## ATTACHMENT II

### Justification and Safety Analysis

The proposed change to the McGuire Technical Specifications, Section 5.0, Design Features, incorporates a second potential radioactive liquid effluent release point on Figure 5.1-4.

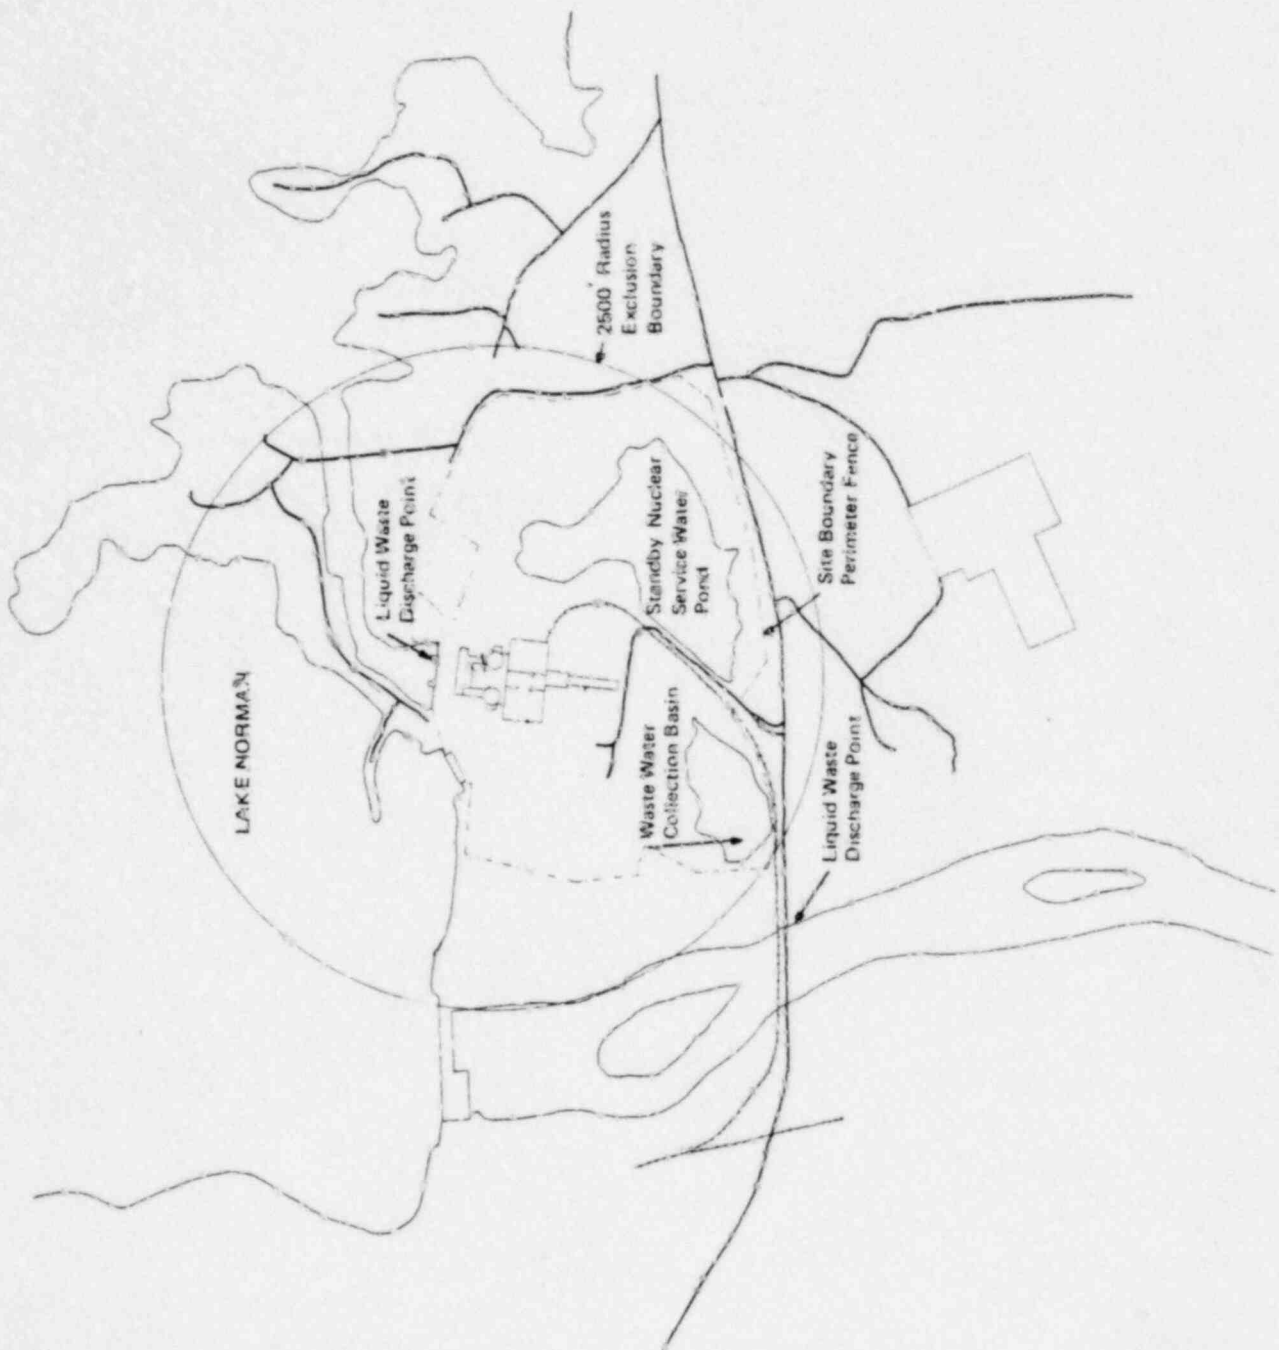
The proposed revision consists only of a figure change to show an additional potential radioactive effluent release point, to more accurately reflect station design and practice when operating with a primary to secondary steam generator leak.
